**APPLICATION REVIEW FOR  
LOW IMPACT HYDROPOWER INSTITUTE  
CERTIFICATION  
of the  
RED BRIDGE PROJECT NO. 10676**

**July 26, 2012**

**Application Reviewer: Patricia McIlvaine**

**RED BRIDGE PROJECT - FERC PROJECT NO. 10676**

**Exhibit B:** Collins production graphs

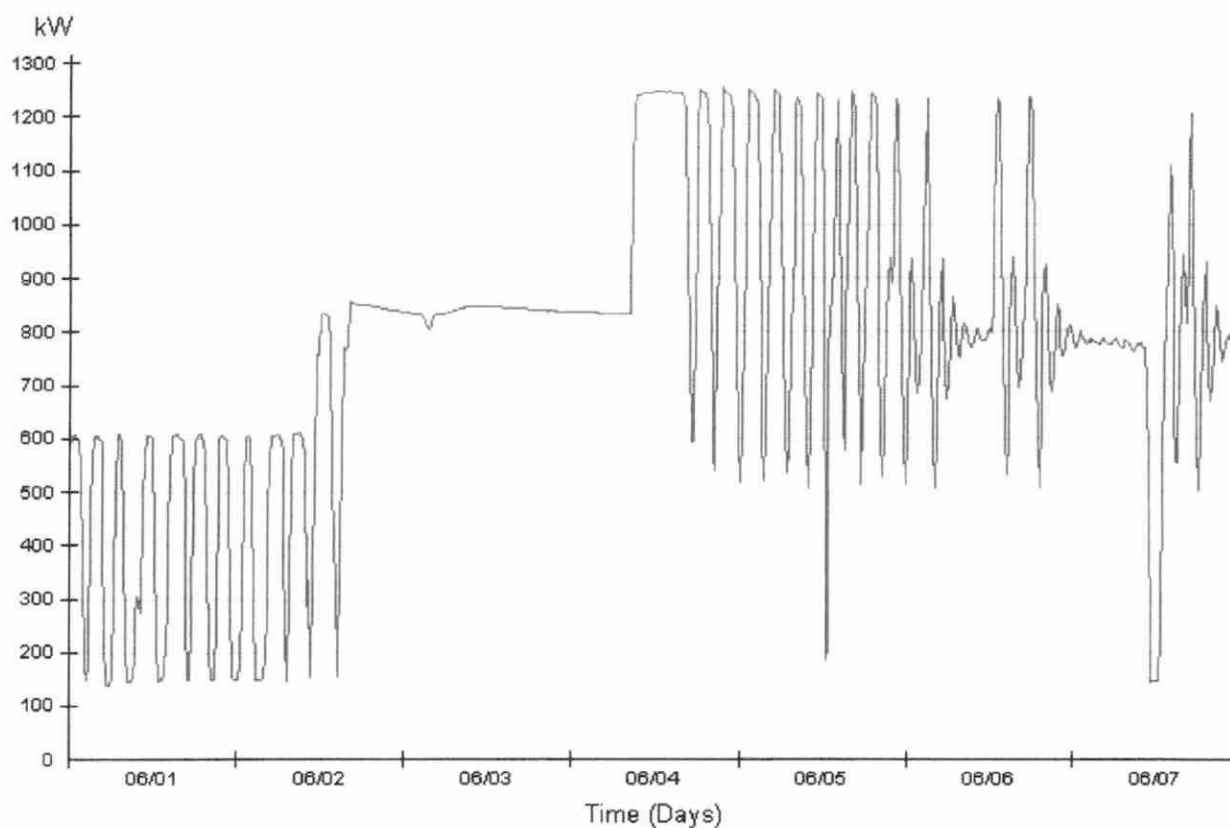
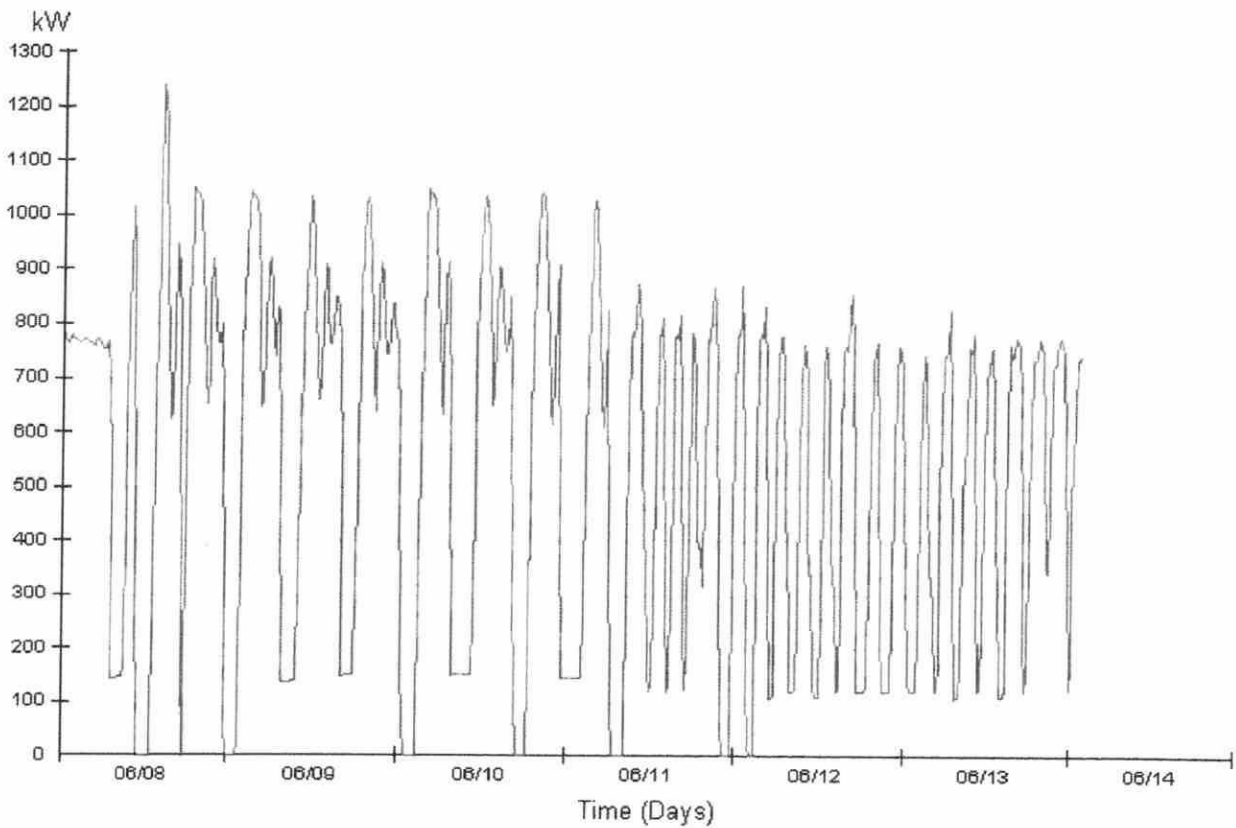
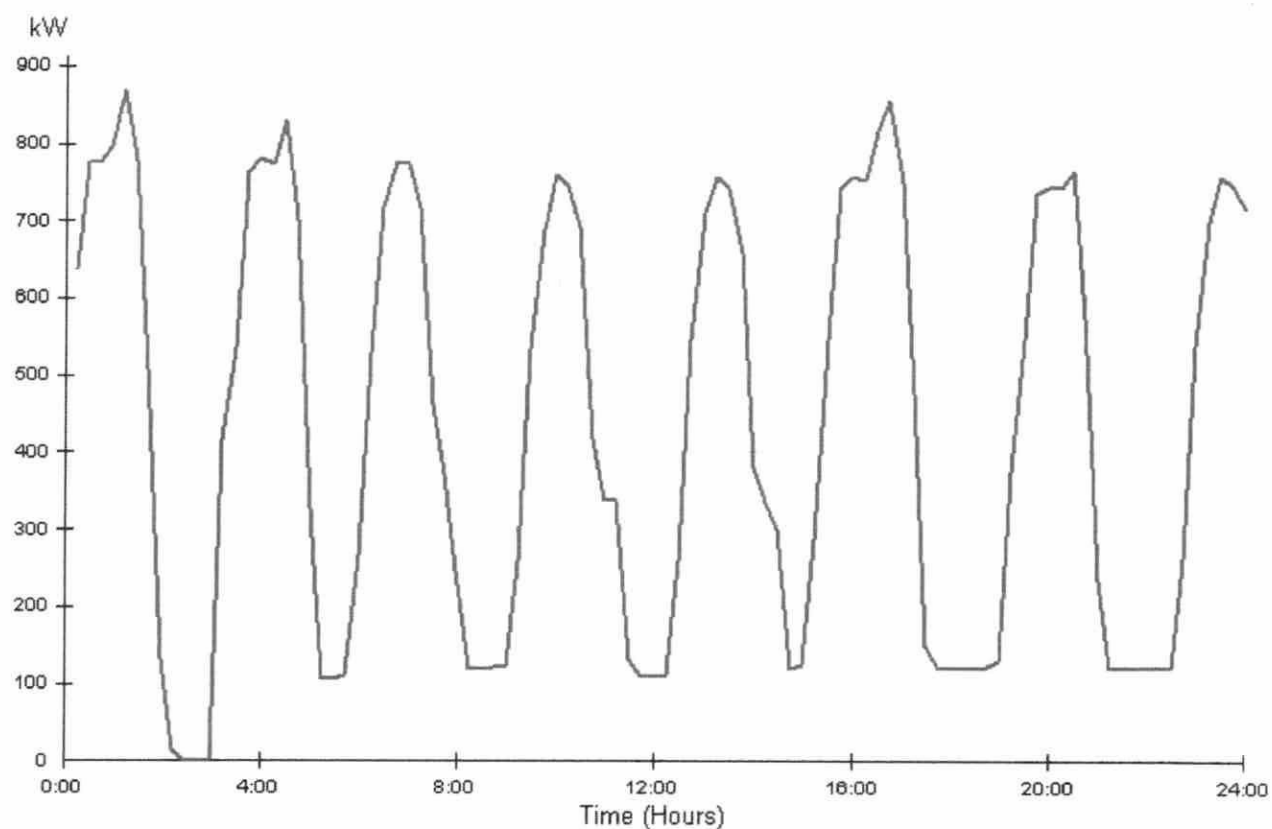
What I have to stress is that Collins PLC cannot keep up with this erratic flow behavior. It seems to overshoot the amount of change because I think it uses a PID loop which looks at the rate of change and makes its adjustment accordingly. Because of the on and off changes between min flow discharge and then full rated flow for the turbines during a very short period of between 1 – 1.5 hours, followed by shutting the river off again back to the min flow discharge rate, Collins' program never gets back to a steady state where flows are constant. Instead, I think that the program computes these radical up ticks and down ticks in the flows coming into its impoundment. Accordingly, Collins program over corrects frequently. I think that this causes Collins equipment to cycle from stop to full two turbine gate opening back to about 100 kW, and then sometimes up over 1,000 kW, and often to 1,500 kW for a very short time, only to find the river level dropping again. So, on June 12<sup>th</sup>, while the gauge shows only four complete cycles, Collins went through eight production cycles triggered by the abruptness of the on and off cycling upstream at Red Bridge Station.

Whether the Red Bridge Project cycles once a day, every day (for example, during the mid-1980s) or several times a day (June 12), Collins' control system should be designed to react to changes in river flows within a very short time period. The letter from Collins clearly states that its units are operating as designed. Its control system detects the change in river flow and operates the units (they load up, unload, come on and off-line). As taken directly from the Collins Letter, "What I have to stress is that Collins PLC cannot keep up with this erratic flow behavior." The various resource agencies, which have jurisdiction over this project, have never found the Project's flows to be erratic or detrimental.
